Appl. No.: 10/737,040
Amdt. dated 06/22/2005
Reply to Office action of March 2, 2005

REMARKS/ARGUMENTS

Patent Application Publication Nov. 18, 2004 Sheet 1 of 16

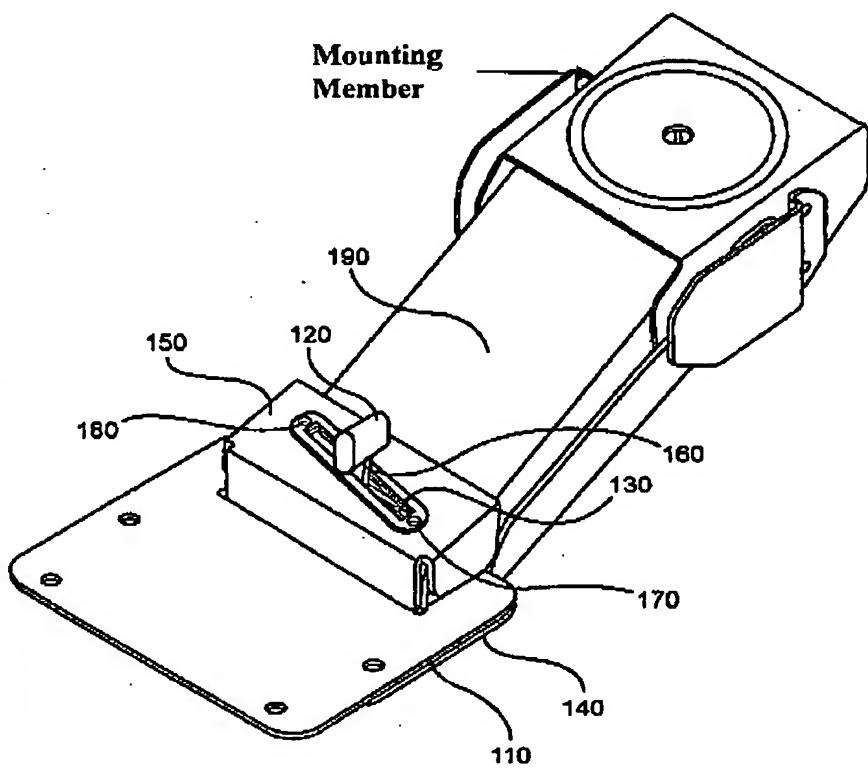
The Examiner also objected to the drawings because they allegedly "fail to show 'auxiliary support mechanism', 'a mounting member', 'a second elongated slot', 'an acute angle with respect to the substantially parallel slot', and 'a spring means mounted on the third member in a manner effective to urge the third member into an upward position'. The Applicant respectfully traverses this objection.

The Examiner alleges that the drawings of the above-identified application fail to show an "auxiliary support mechanism". The Applicant respectfully traverses the Examiner's objection and submits that Figure 1 shows an 'auxiliary support mechanism'. In particular, the Applicant notes that paragraph 39 states "[t]urning to FIG. 1, the adjustable support mechanism 100". Thus the above-identified application illustrates an 'auxiliary support mechanism'.

The Examiner also alleges that the drawings of the above-identified application fail to show 'a mounting member'. The Applicant respectfully traverses the Examiner's submits that one of ordinary skill would recognize the structure in Fig. 1 attached to the end of structure bearing point 190 away from box member 150 to be a mounting member. See also the Applicant's earlier U.S. Patent No. 5,924,664 for further elucidation of what those of ordinary skill understood the term "mounting member" to mean in the context of an adjustable support mechanism.

FIG. 1

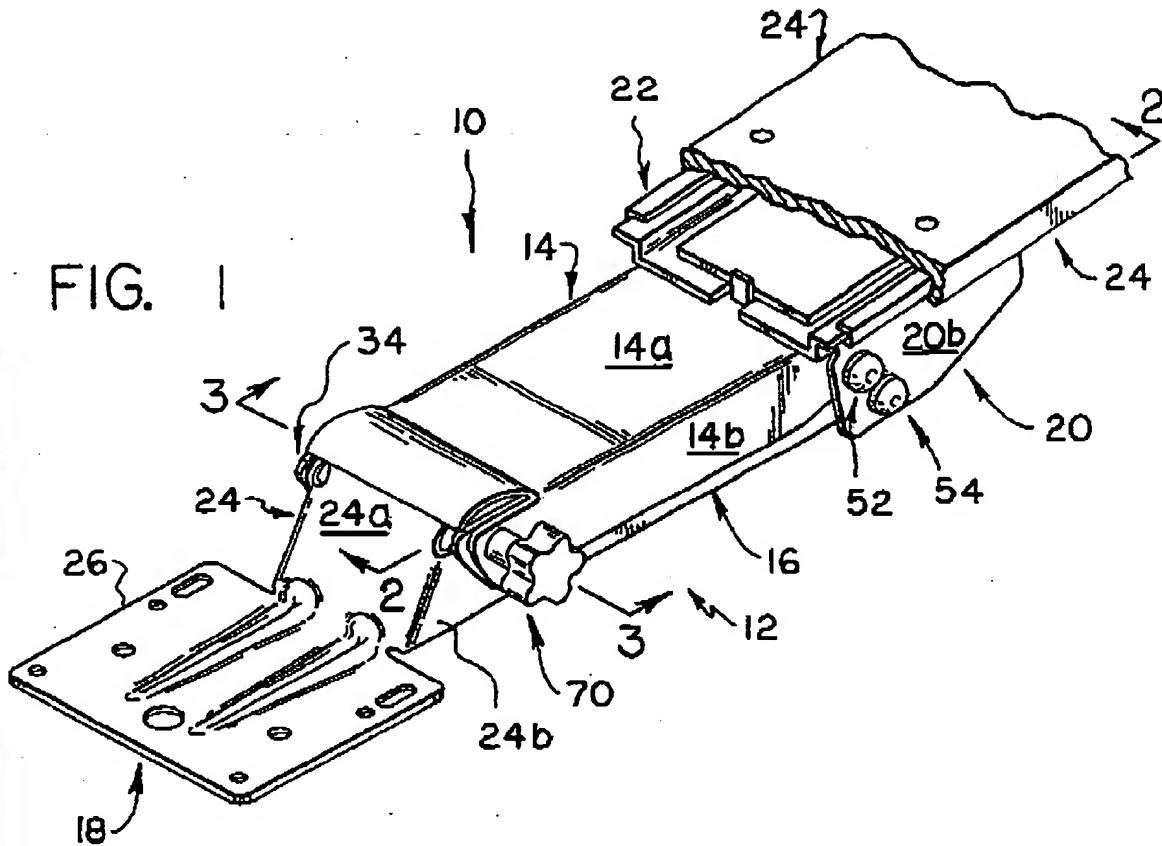
The Examiner alleges that "Pangborn et al. teaches an auxiliary shelf adjustment mechanism comprising: a first member (20, 24) having a plurality of surfaces mounted on an end of an auxiliary support mechanism distal to the mounting member of the auxiliary support mechanism, . . ." Office Action at 5. While this assertion's use of the terms of the claim might be consistent with some undefined dictionary, it is inconsistent with the above-identified application. For this reason, the Applicant respectfully submits that the Examiner's construction of the claim is not reasonable.

Thus, we turn to examine the Pangborn patent to ascertain what part, or parts, connect Pangborn's auxiliary support mechanism to a primary support. From Fig. 1 of Pangborn, it is obvious that the mounting member of Pangborn's auxiliary support mechanism is the structure labeled 20. The text of Pangborn, e.g., "second or rear ends pivotally connected to a second element 20, which is adapted for mounting on a suitable base, such as may be defined

Because Pangborn element 20 is the mounting member, element 20 cannot be distal to the mounting member. Thus, the Examiner has not made a *prima facie* showing that Pangborn discloses the claimed subject matter. For this reason, the present rejection must be withdrawn.

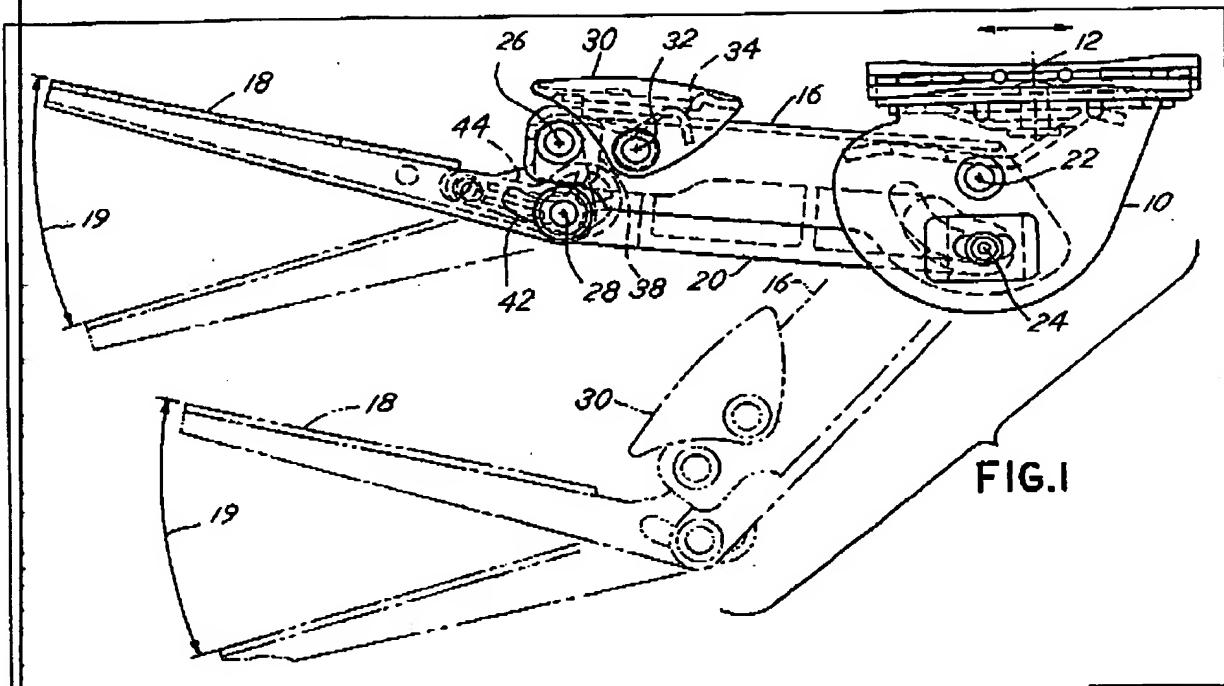
The Examiner alleges that "Hudson teaches an auxiliary shelf adjustment mechanism comprising: a first member (10) having a plurality of surfaces mounted on an end of an auxiliary support mechanism distal to the mounting member . . .": Office Action at 6. An implicit premise in the Examiner's assertion is that first member (10) is not the mounting member.

However, a review of the Hudson patent establishes that this premise is false. Specifically, as shown in Fig. 1 of Hudson, first member (10) is the member that connects the auxiliary shelf mechanism to the main surface, i.e., first member (10) is the mounting member. Hudson confirms this analysis of Fig. 1 by stating: "slide bracket assembly 10 which is slidably mounted in a bracket (not shown) that is mounted to the underside of a work surface, desk or platform." Col. 2, lns. 51 – 54.

Because Hudson's first member 10 is the mounting member, first member 10 cannot be distal to the mounting member. Thus, the Examiner has not made a *prima facie* showing that Hudson discloses the claimed subject matter. For this reason, the present rejection must be withdrawn.
